Design Review Board Meeting
 December 3, 2009
 Agenda Item: **E1**

STAFF REPORT

To: Members of the Design Review Board
From: Associate Planner Tyler
Subject: 110 Gilmartin Drive; File No. 709095; Site Plan and Architectural Review for Construction of a New Single-Family Dwelling with a Floor Area Exception
Reviewed By: _____

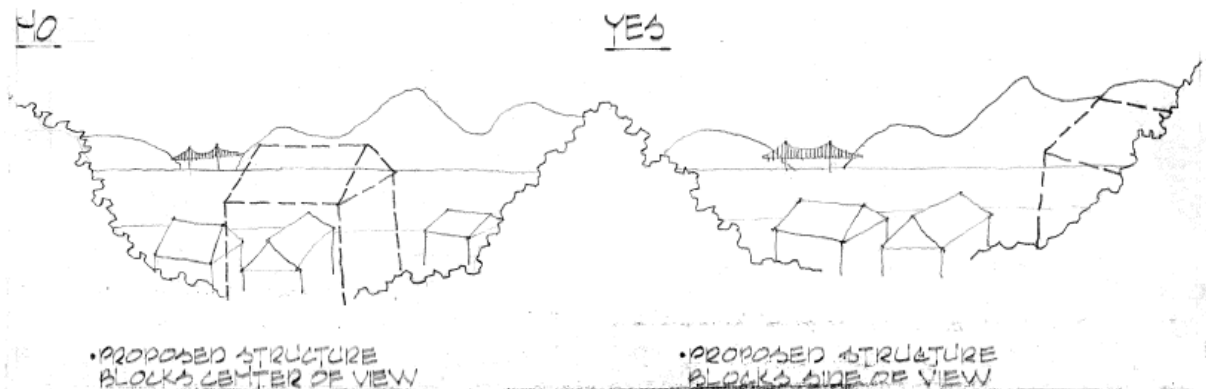
The property owner of 111 Gilmartin Drive (northwest) has the greatest potential for view impacts from the proposed house, due to the second story office and rooftop deck. This home sits above the subject site to the northwest, and has panoramic views of the Bay Bridge to the Marin Headlands. As shown in Exhibit 7, the photographs submitted by the homeowner depict the story poles encroaching into various water views. Staff visited the site to determine the extent of view blockage and discovered that from various primary living areas of the home (i.e. living room, family room, dining room, kitchen, and nook) the view blockage would be more pronounced in one room, but not as pronounced in another. In sum, the second story office and rooftop deck, as

proposed, would block portions of Belvedere, Tiburon Cove, and San Francisco Bay, depending in which primary living area one is sitting. The greatest impact would be from within the family room, which would lose a majority of the water view.

It would appear that the second story office and rooftop deck should be relocated on the site or eliminated in order to maintain existing views for 111 Gilmartin Drive, as well as to reduce privacy impacts for both 109 Gilmartin Drive and 300 Round Hill Road. In addition, the overabundance of exterior lighting on the site should be reduced. Staff would recommend that the project be continued, and direction be given to the applicant on possible design alternatives for the second story office and rooftop deck, and reduction in exterior lighting.
